PROPOSED TECHNICAL SPECIFICATIONS CHANGES

SAFETY LIMIT, REACTOR CORE

CONTROL ROD AND POWER DISTRIBUTION LIMITS,
SHUTDOWN REACTIVITY

POWER AUTHORITY OF THE STATE OF NEW YORK
INDIAN POINT 3 NUCLEAR POWER PLANT
DOCKET NO. 50-286

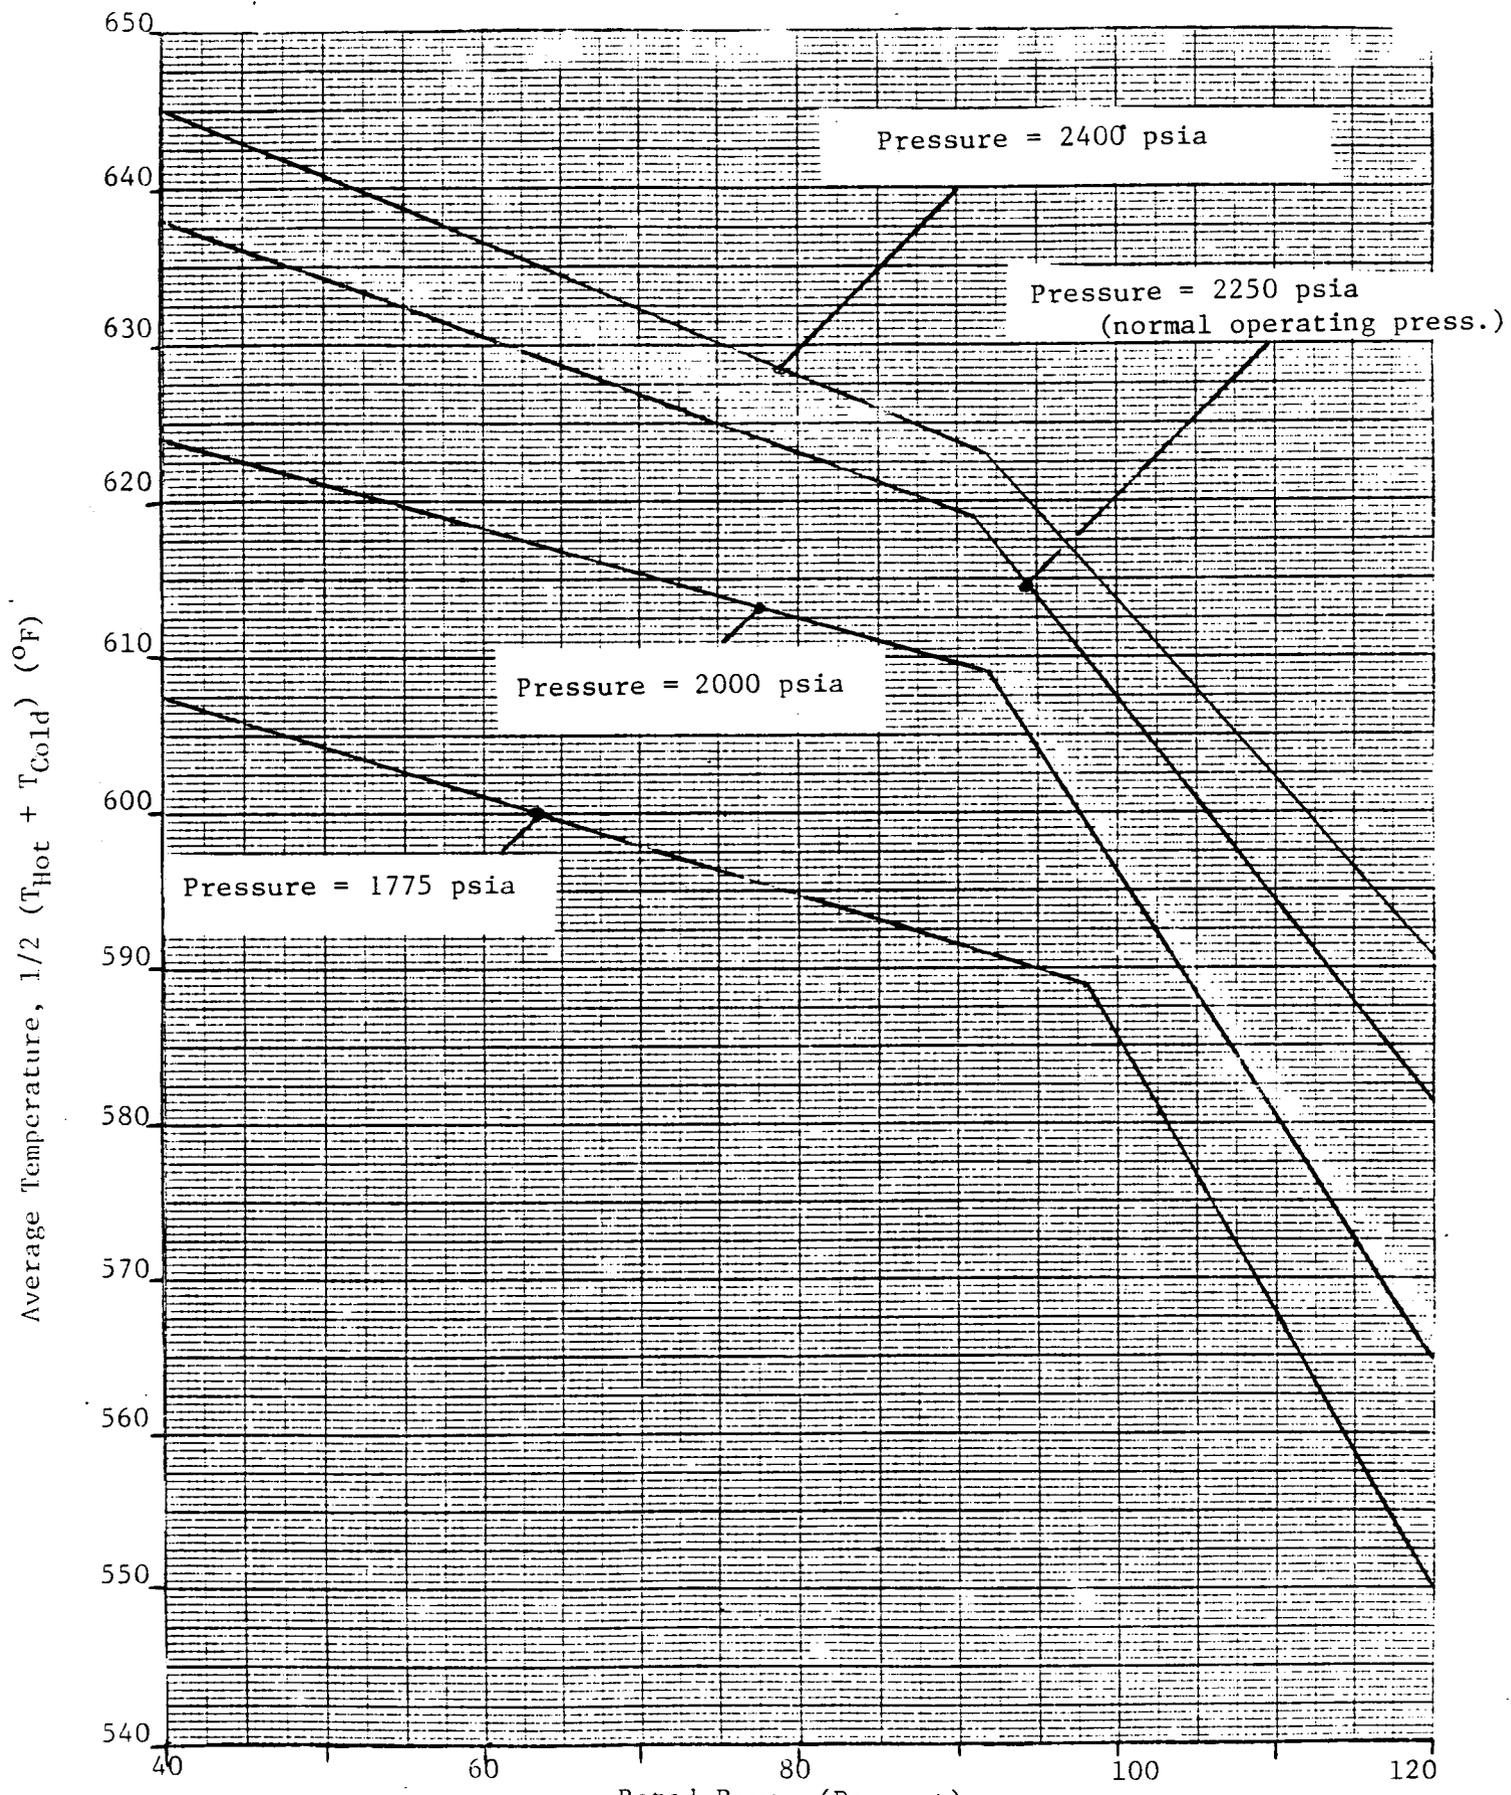
The curves of Figure 2.1-1 represent the loci of points of thermal power, coolant system pressure and average temperature for which the DNBR is no less than 1.30. The area where clad integrity is assured is below these lines.

The calculation of these limits includes an $F_{\Delta H}^N$ of 1.55, DNB penalties for increased pellet eccentricity, local power spikes, 8% uncertainty in $F_{\Delta H}^N$, up to 24% steam generator tube plugging, and a reference cosine with a peak of 1.55 for axial power shape.⁽³⁾

Figure 2.1-1 includes an allowance for an increase in the enthalpy rise hot channel factor at reduced power based on the expression:
